GALT JOINT UNION ELEMENTARY SCHOOL DISTRICT

Fairsite Elementary Portables Renovation

ADDENDUM #1

DATE: March 21, 2023

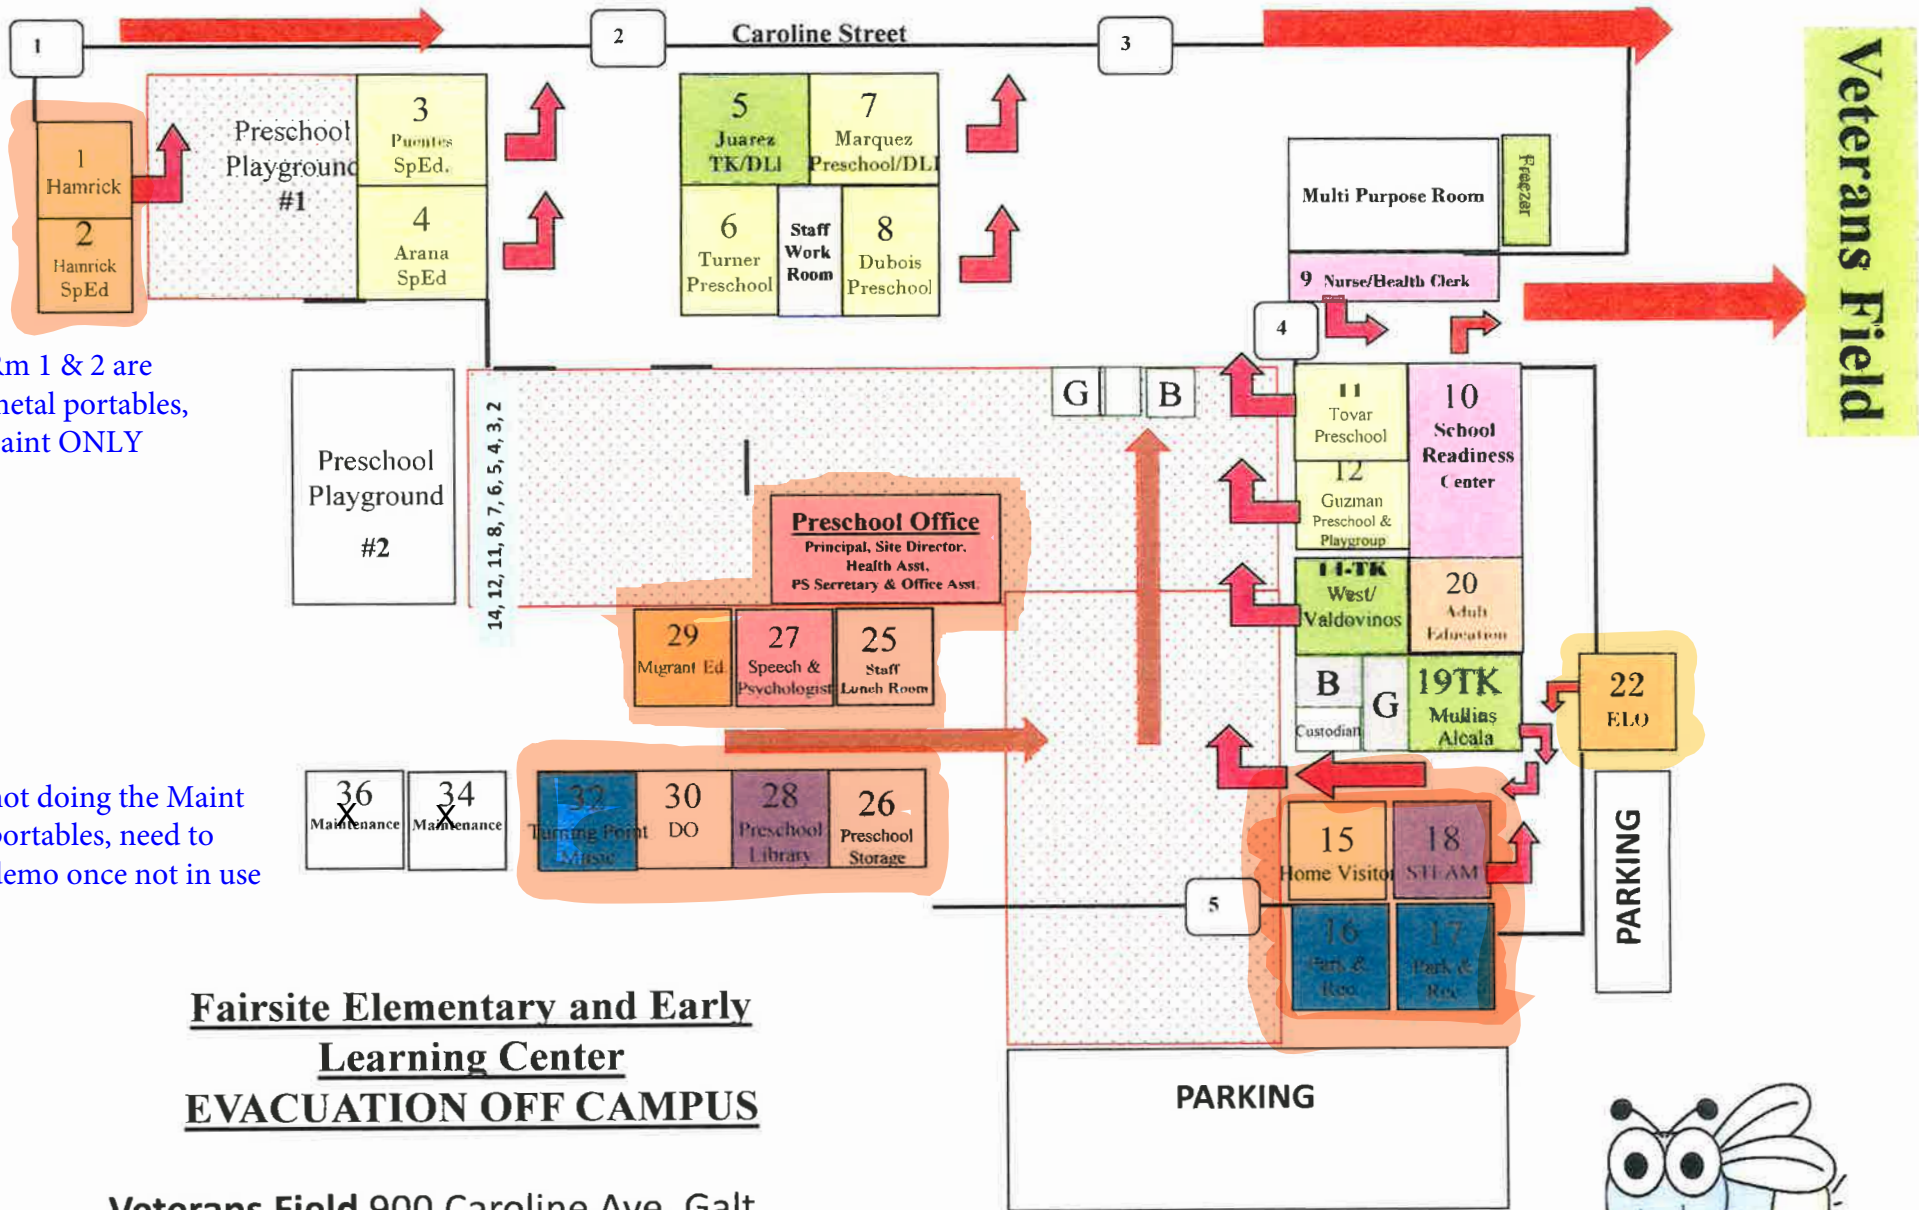
5. Can you please provide a map with the exact location of all portable buildings which are a part of this project?
 - **Map is attached to this addendum, portables are shaded and consist of:**

Rm 1 & 2 are metal portables, paint ONLY

not doing the Maint portables, need to demo once not in use

- i. **Rooms 1 & 2: Metal portables, exterior paint only.**
 - ii. **Rooms 15, 16, 17, 18, 22, 25, 26, 27, 28, 29, 30, 32 and the pre-school office, dry rot repair where needed and exterior paint.**
